THOMAS JEFFERSON HALL
UNITED STATES MILITARY ACADEMY
WEST POINT, NEW YORK

VOLUME – IV

Option A-1
Reduce height of 2nd floor by 24" (i.e., lower 3rd floor slab 24")

Option A2 –
Replace Exposed Double-T Ceilings with Flat Slab and Gypsum Board Ceiling

4.21.05 A405 - A3

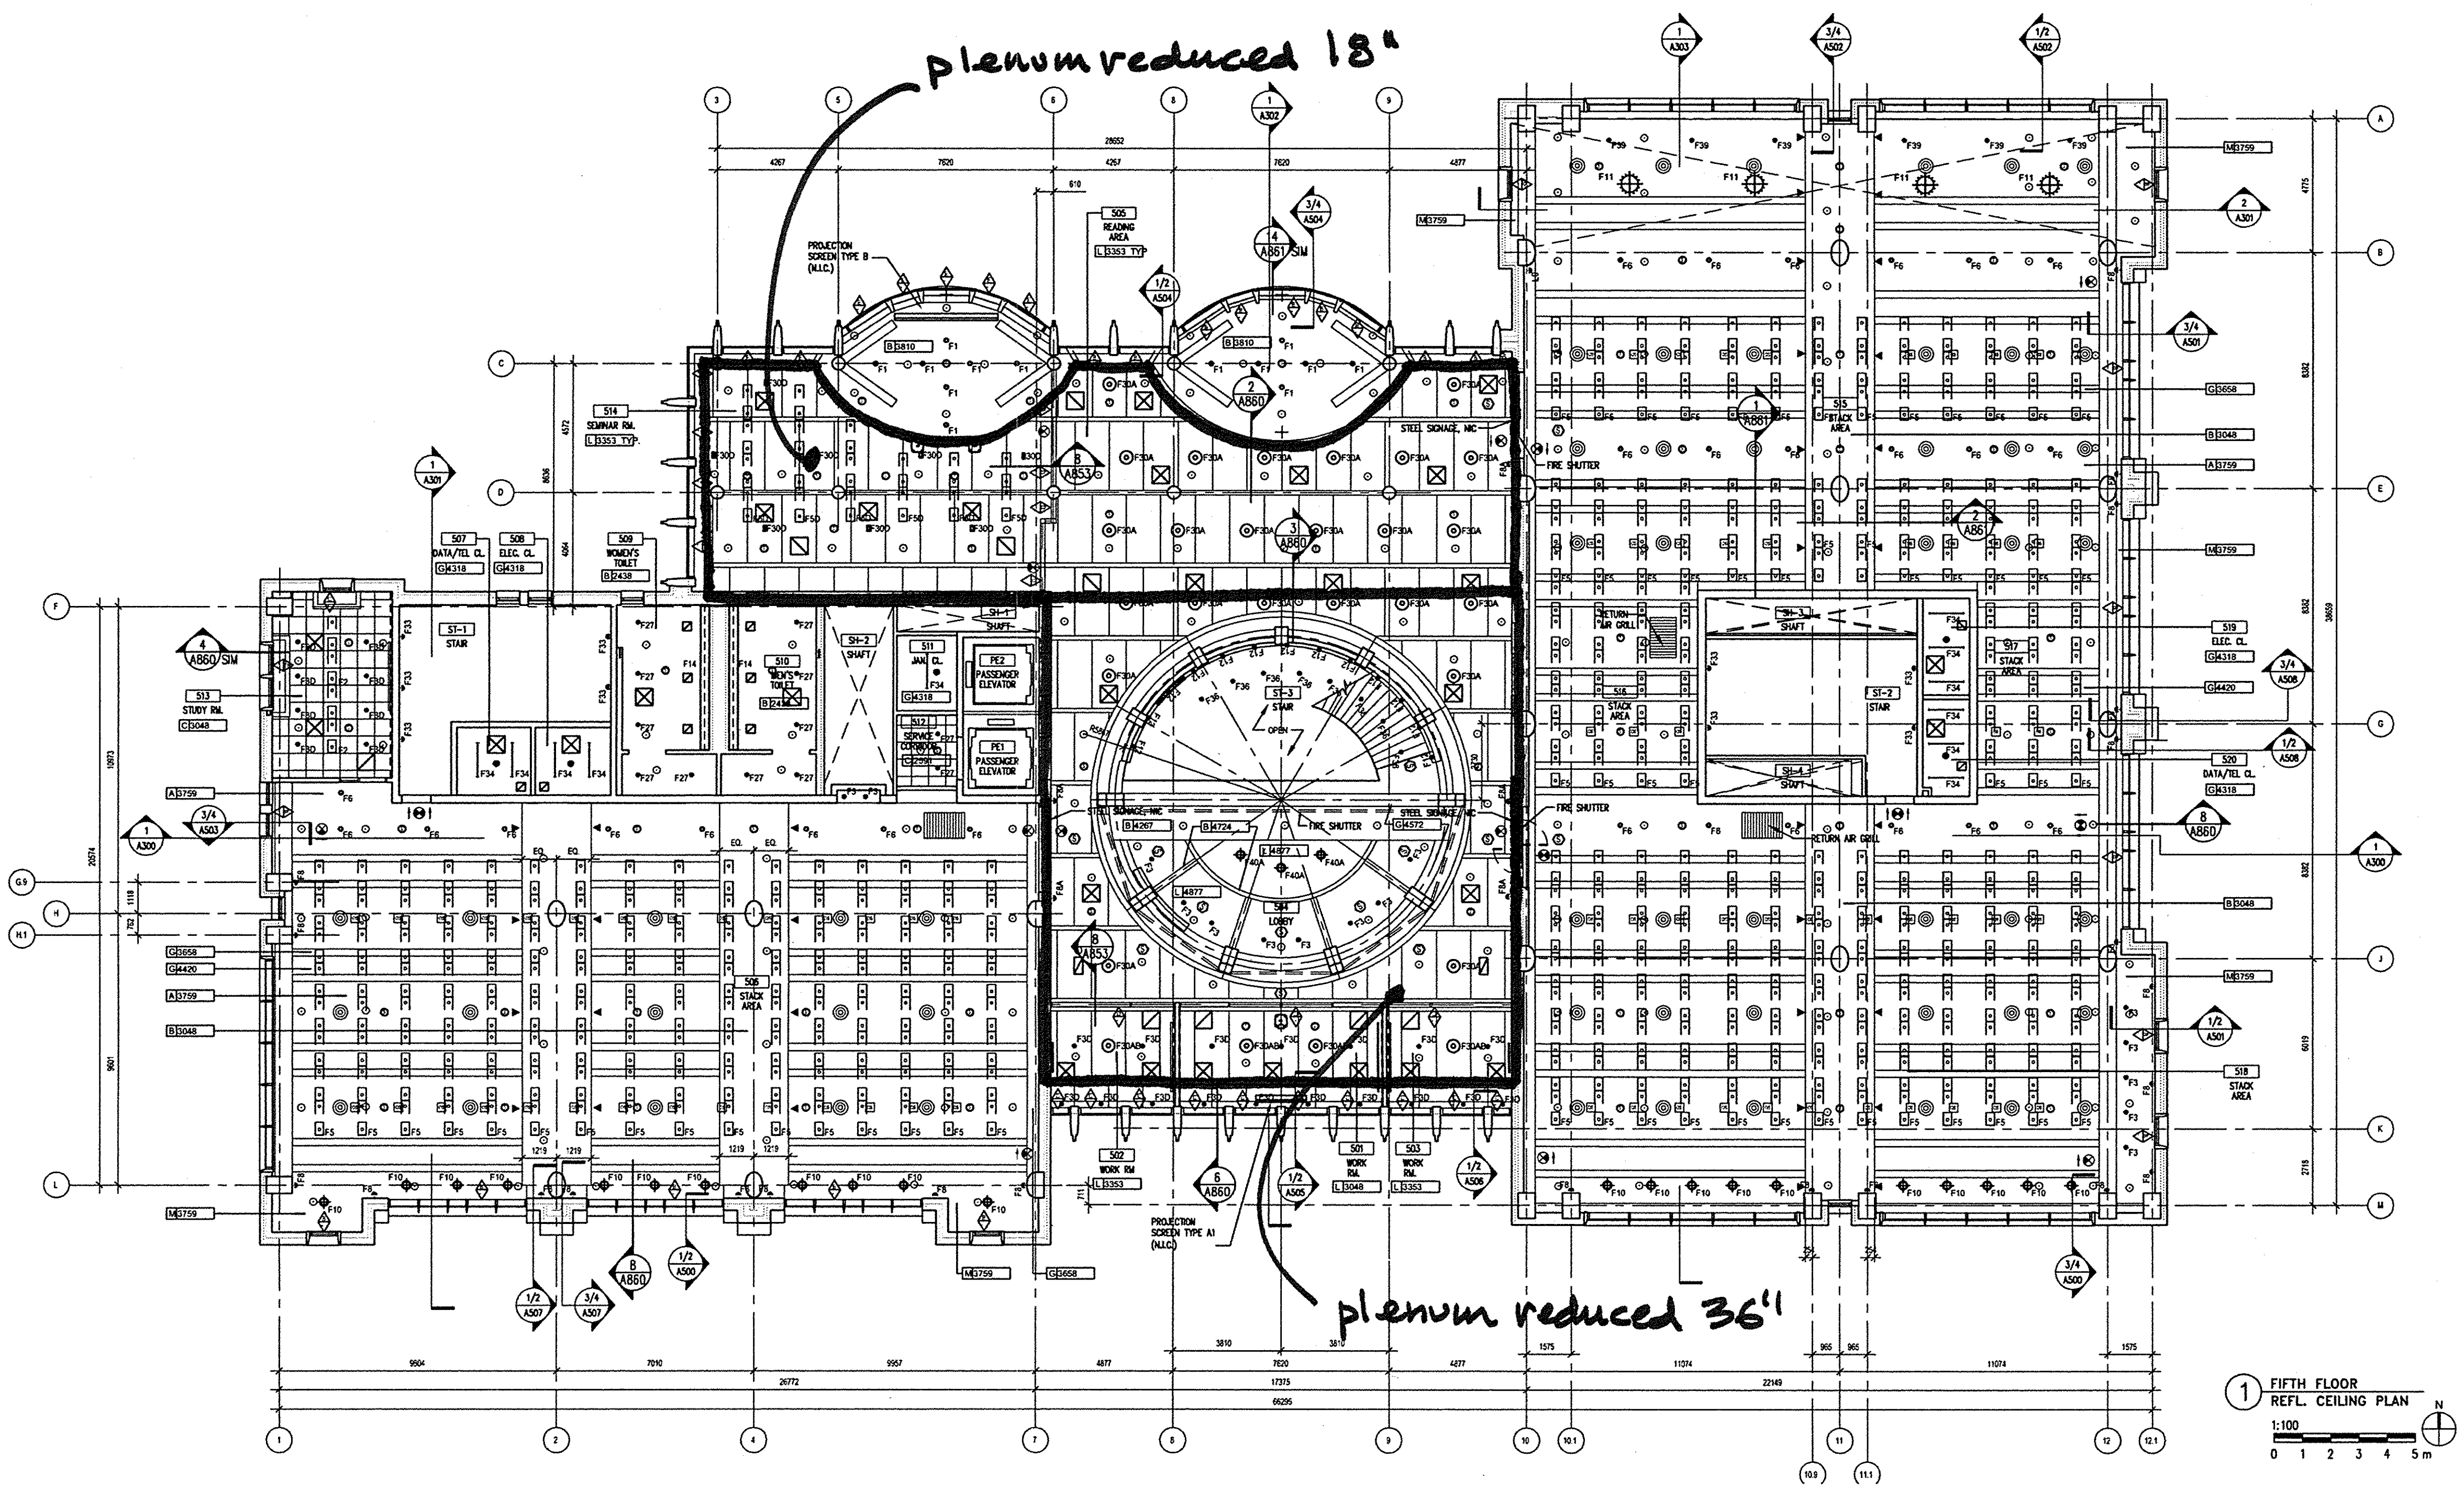
Architectural –
- Eliminate User Spaces. See Sheets: A-106-A3, A-107-A3, A-300-A3, A303-A3, A405-A3
- Eliminate secondary slab and lower central portion of primary slab. See Sheets: A-106-A3, A-300-A3, A-303-A3
- Reduce plenum height at part of 5th Floor. See Sheet A-405-A3
- Alter exterior elevations. See Sheets: A-200-A3, A-201-A3, A203-A3
- Provide exterior metal stairs to roofs of new penthouses. See Sheets: A-106-A3, A-107-A3
- Eliminate elevator and stair bulkheads. See Sheets: A-106-A3, A-107-A3, A-300-A3, A303-A3
- Relocate two large mechanical units to new lower roof. See Sheets: A-106-A3, A-107-A3, A-300-A3, A303-A3
- Assume same built-up roof system throughout.
- Reduce stair travel distance 18'.
- New exterior steel stairs to connect lower and upper roofs. See Sheets: A-106-A3, A-107-A3, A-300-A3, A303-A3
